January 26, 2024  
IDEA Donna Mechanical Upgrades

## ADDENDUM NO. 1

01 IDEA DONNA - CHILLER YARD  
 CHILLED WATER SCHEMATIC DIAGRAM (9TH GRADE BUILDING)  
 SCALE: NOT TO SCALE

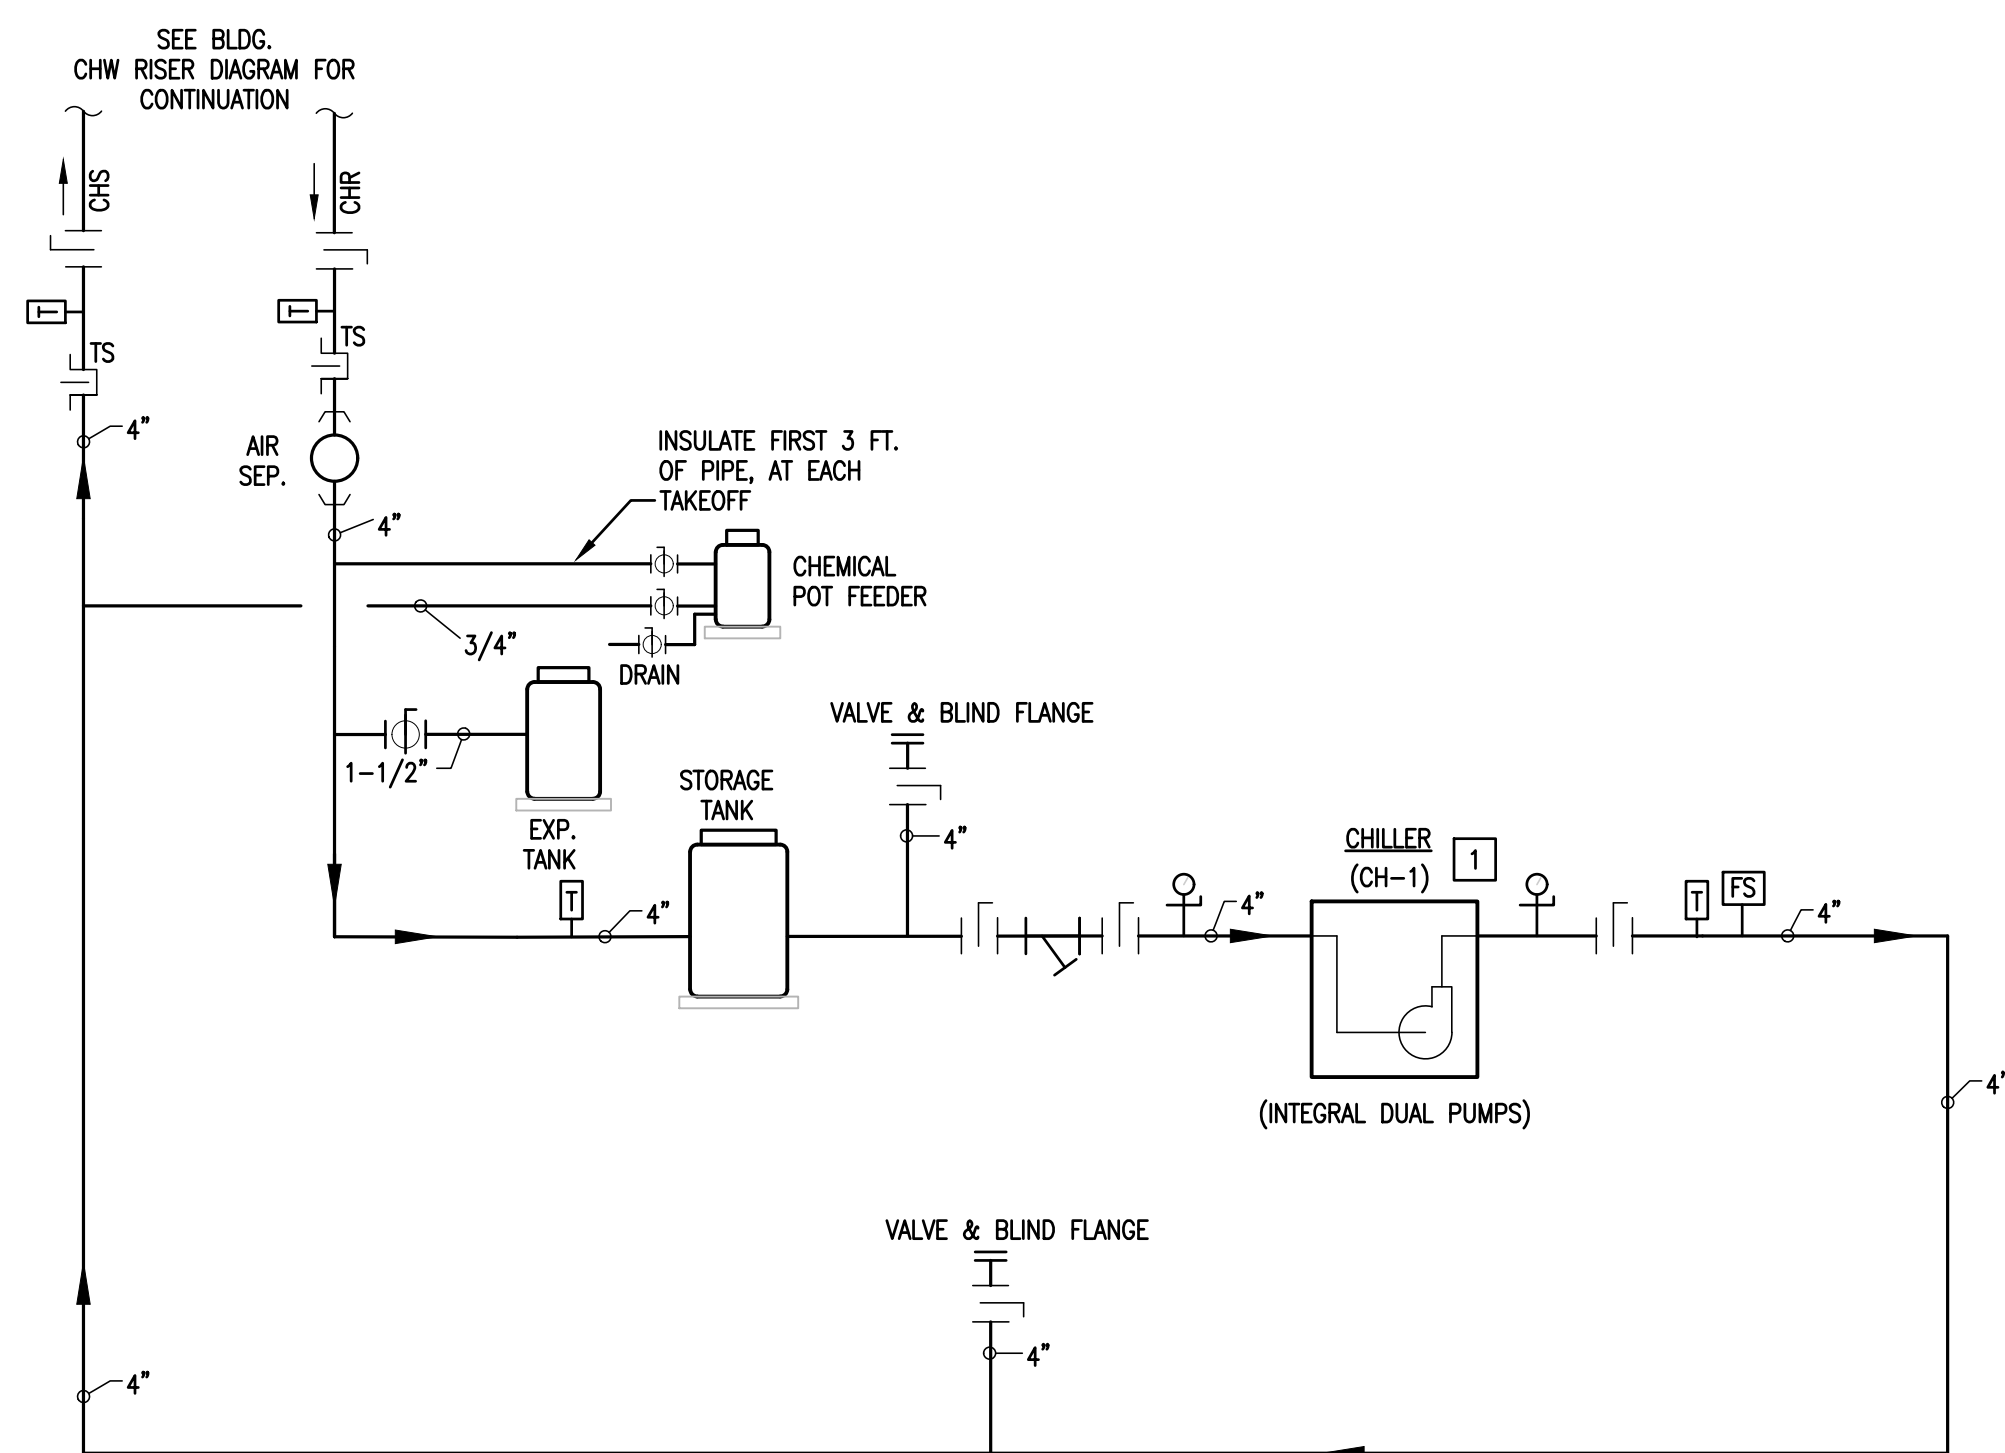
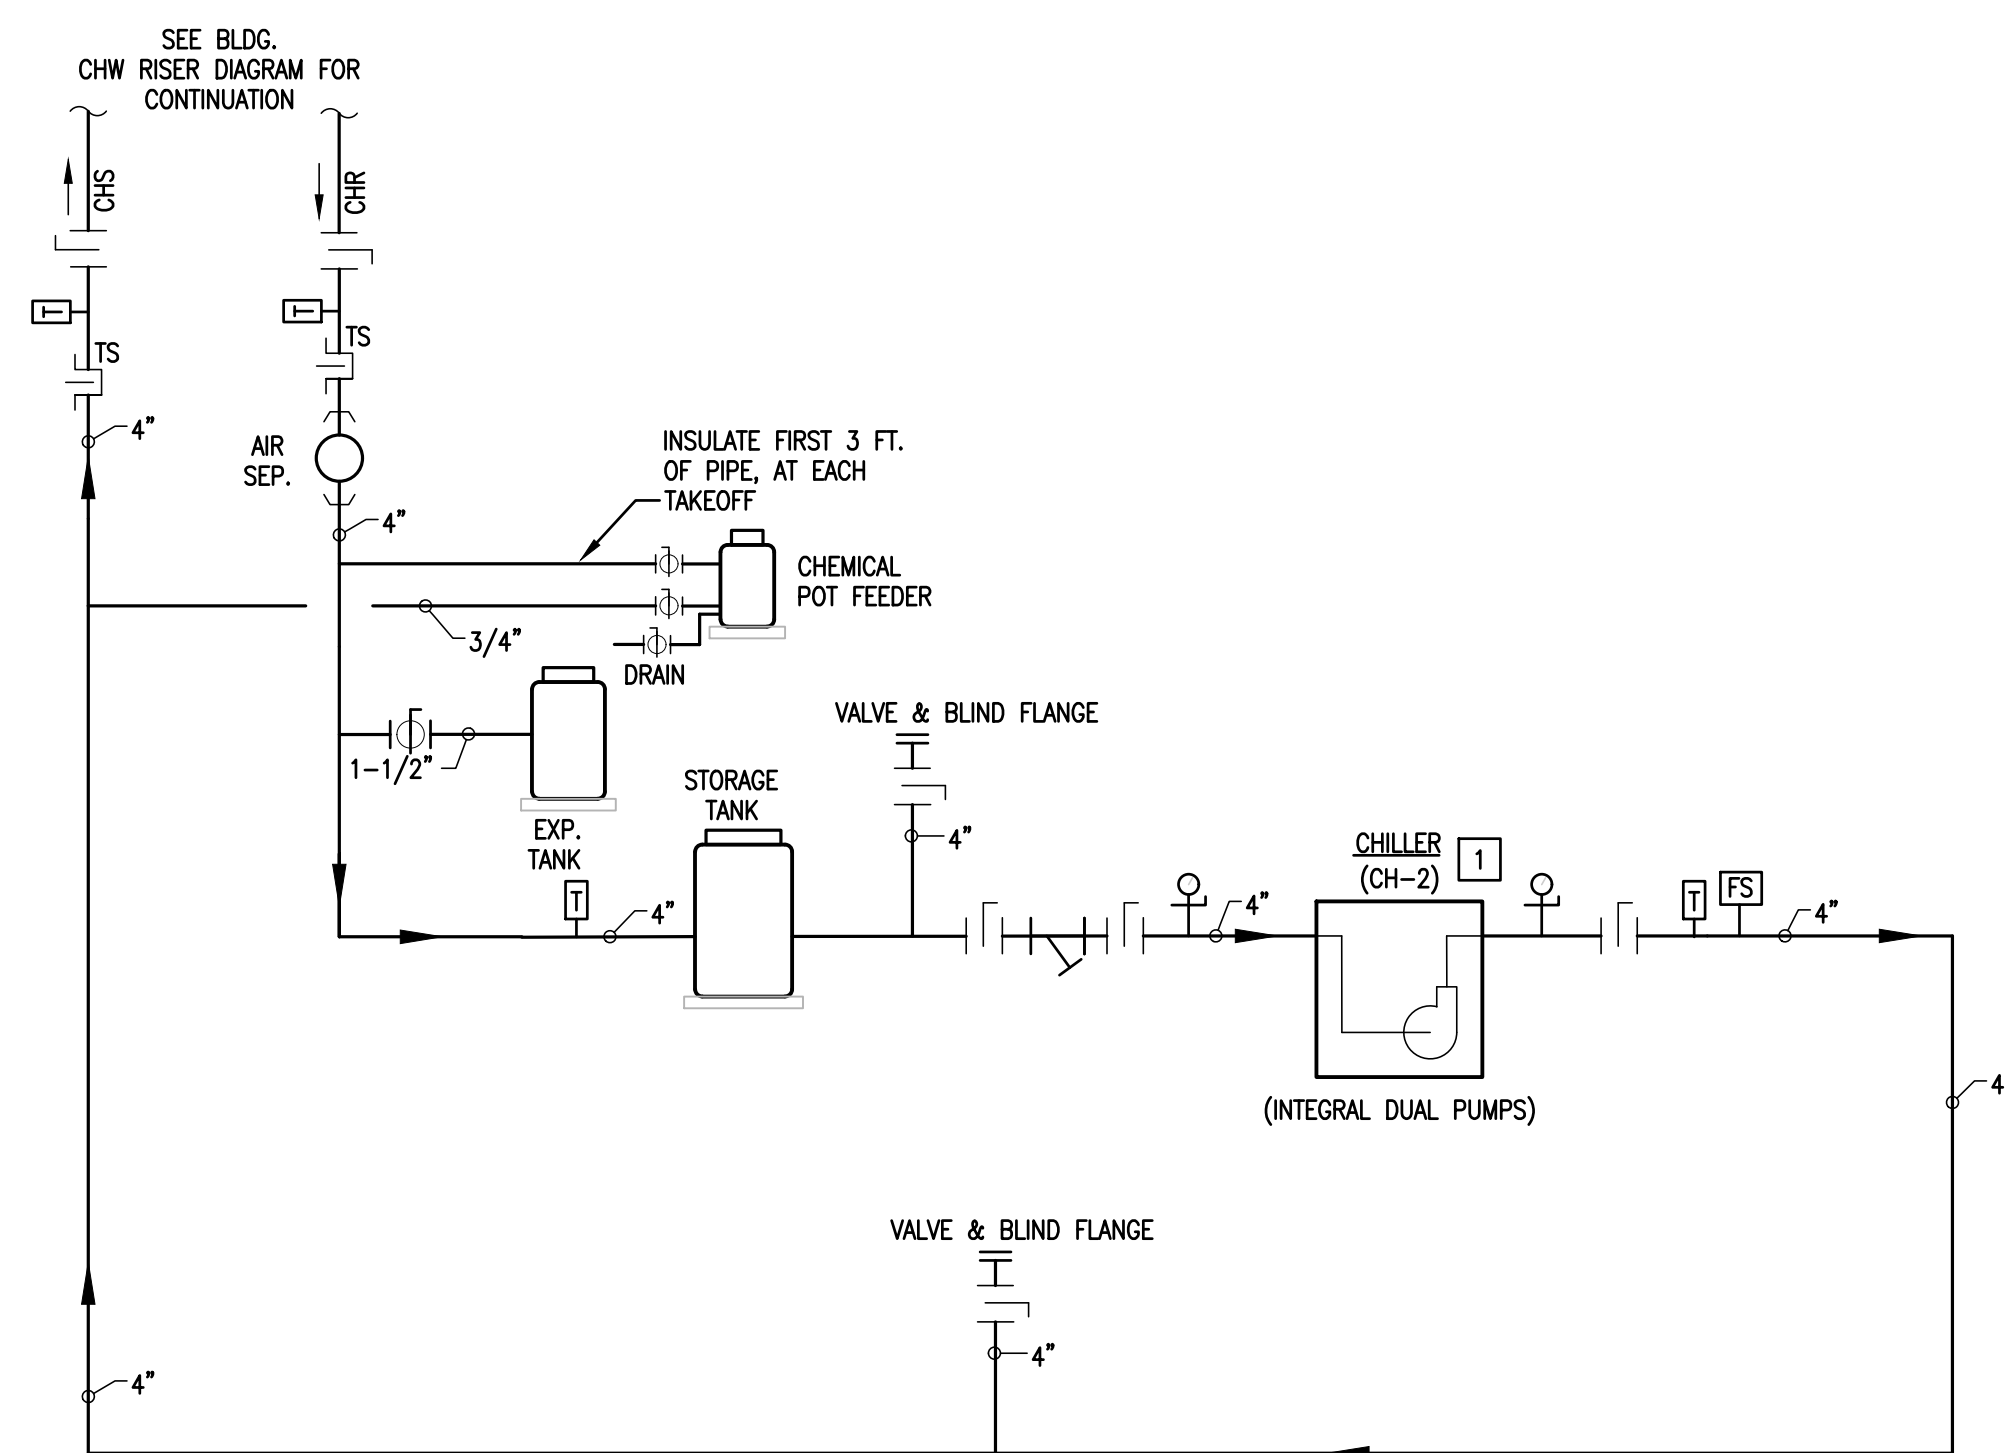
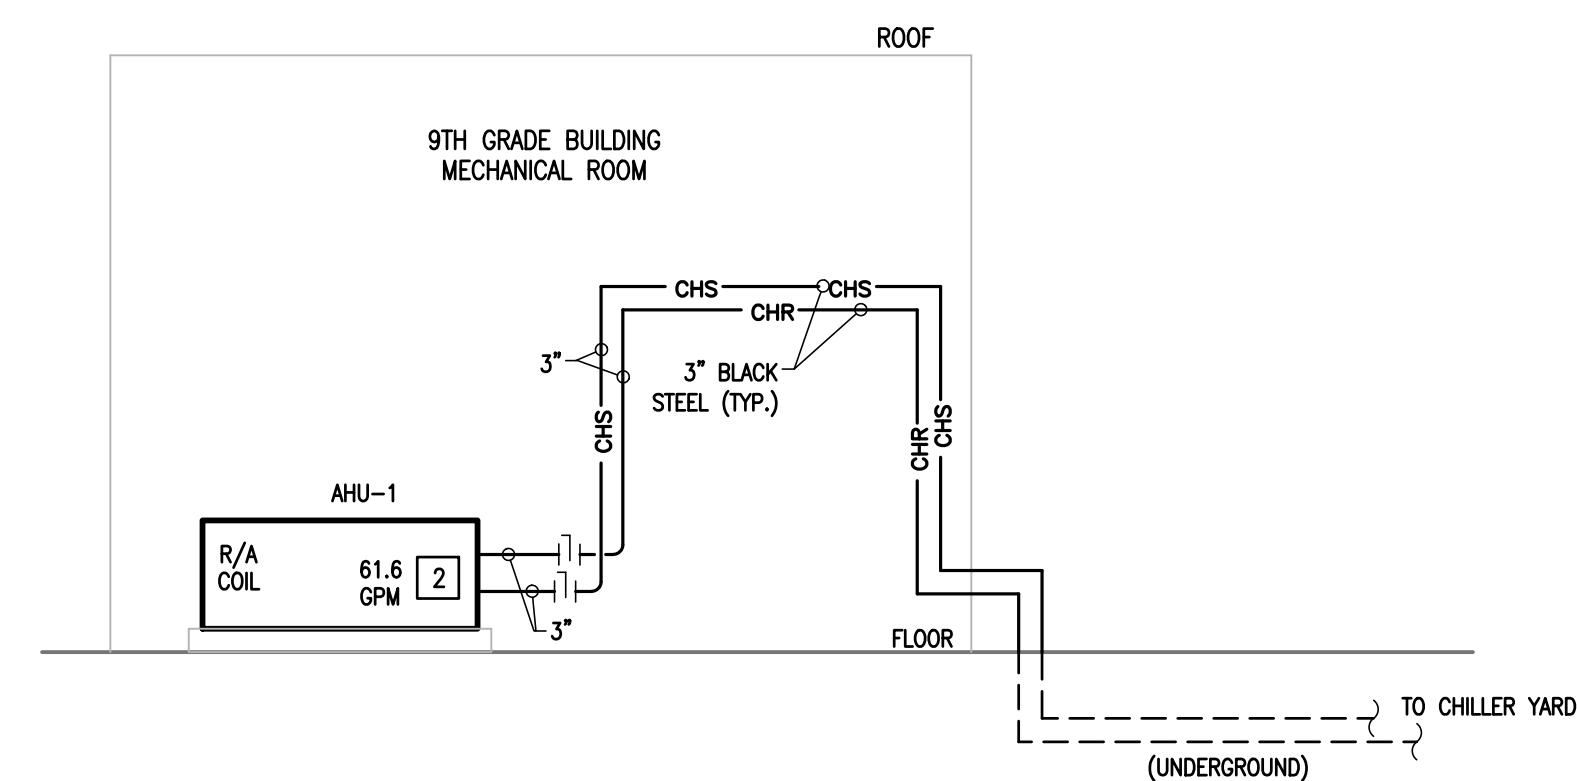
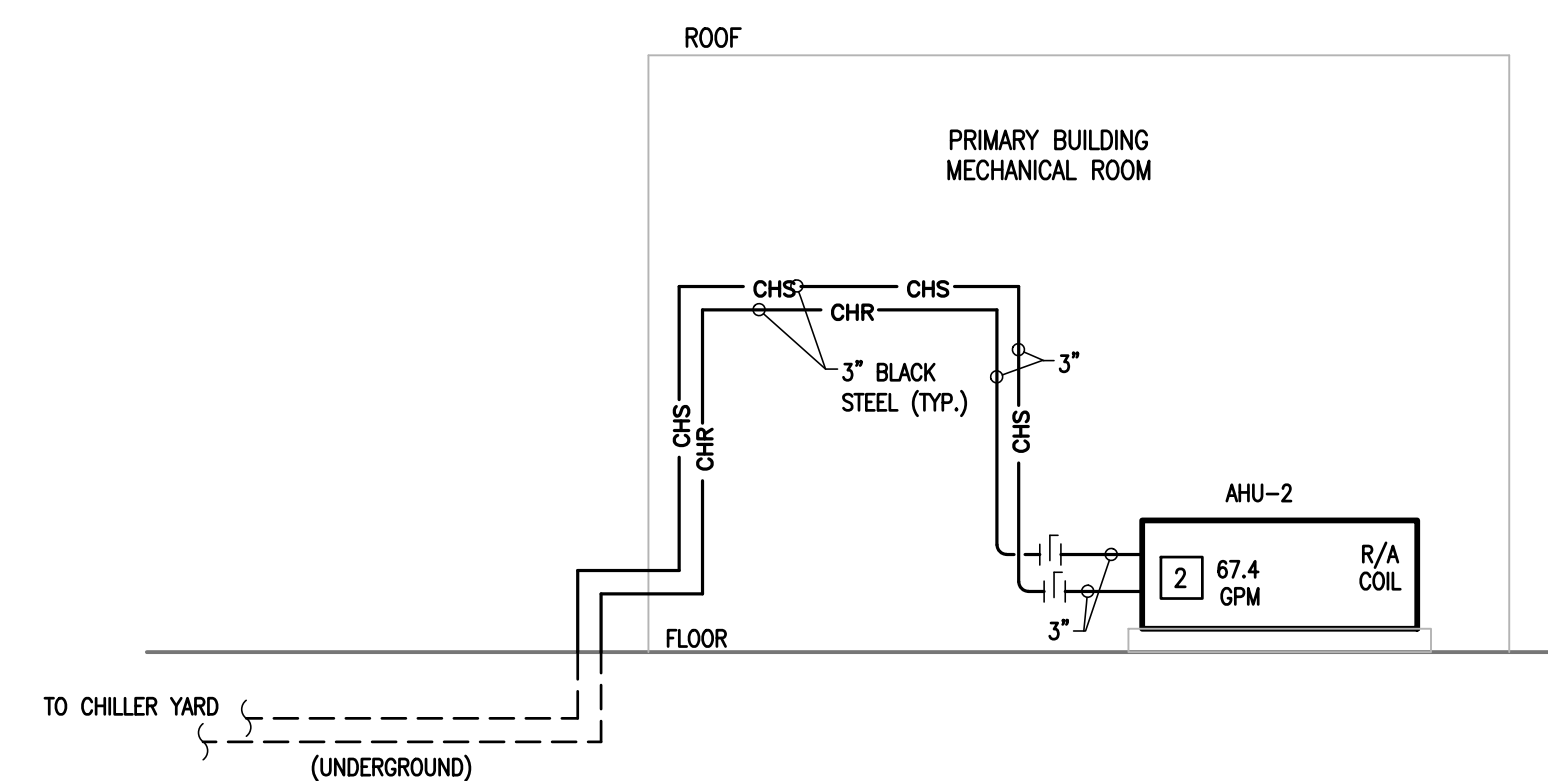
6. Sheet ME3.01:
  - a) Revised Chilled Water Schematic Diagrams. See attached sheet.
